Report and Recommendations of the University Community Planning Group on the Draft-University Community Plan

University Community Planning Group

May 15, 2024

Figure 29: University Community Open Space, D-UCP, p 143

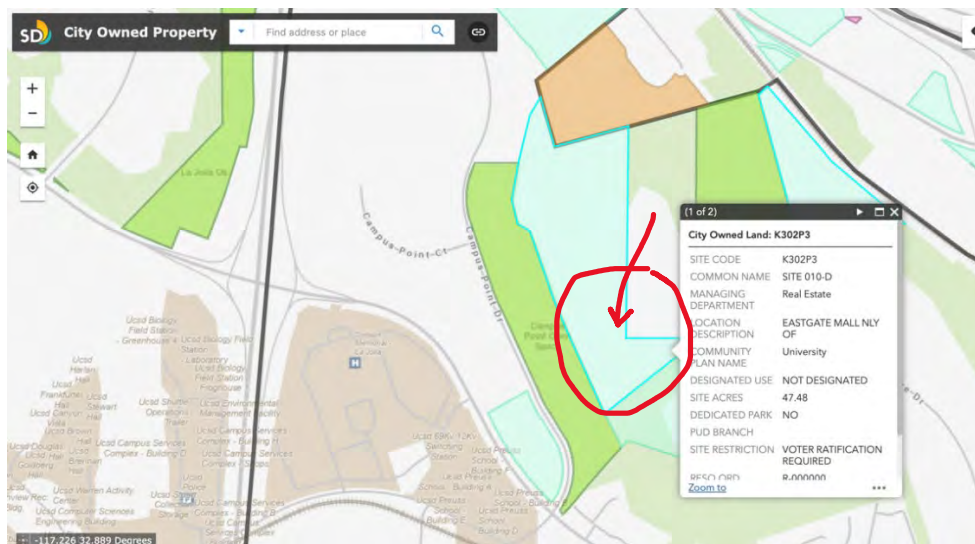
Figure 29 accurately represents the parcels proposed for dedication under Charter sect 55. The parcel misrepresented in the D-EIR and Biological Resources Report (K302 P3) is circled in red. K302 P3 includes two sub-parcels (APN: 343-121-01 & 343-121-05)

Figure 4. Post-Project MHPA and Conserved Lands, Biological Resources Report, D-UCP.

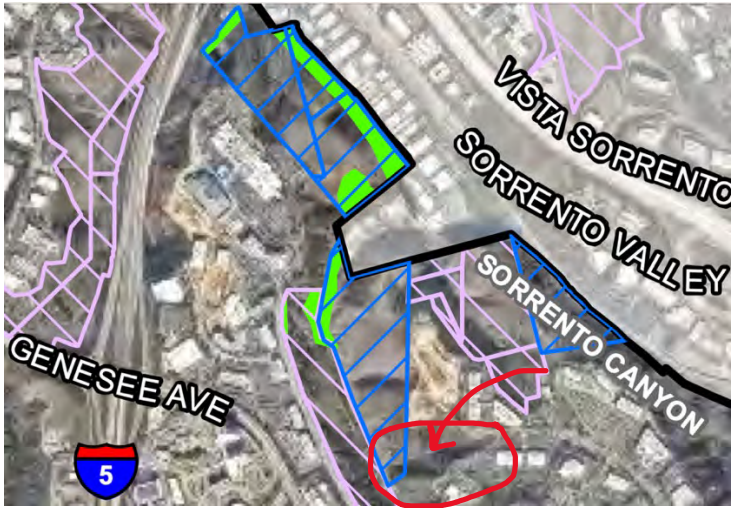
- Figures 4 and 5 of the Biological Resources Report omit a portion of one of the parcels (see below).
- The BRR and D-EIR mis-state the total acreage of the lands proposed for dedication. The D-EIR states that 160.9 acres are proposed for dedication.¹² The correct acreage is approximately 168.79 acres.¹³

Figure 4 omits a portion of one parcel (K302 P3) proposed for dedication. The missing sub-parcel is APN: 343-121-05. It is approximately 5-acres in size.

- **Please correct errors** to ensure consistency between the Draft UC Plan and the environmental documents that support it.
- **Please revise the D-EIR, the Biological Resources Report (Fig 4-5), and the Proposed Zoning Map** to ensure that city owned open space parcels to be dedicated pursuant to Charter section 55 are described accurately and consistently in every part of the Final University Community Plan.
- **Please revise the D-EIR, the Biological Resources Report (Fig 4-5), and the Proposed Zoning Map** to ensure that all of parcel K302 P3 (sub-parcels APN: 343-121-01 & 343-121-05) are included in the Final UCP and associated documents.

- Correct language in Figure 29, University Community Open Space, p 143.

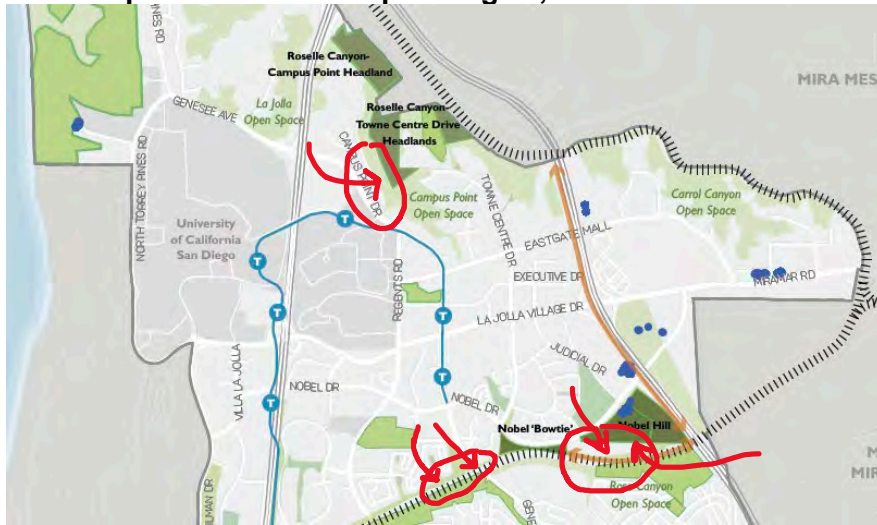
Clarify use of “designated” and “dedicated” open space – it is confusing.

Please complete UCPG recommendation to fully correct Fig 29:
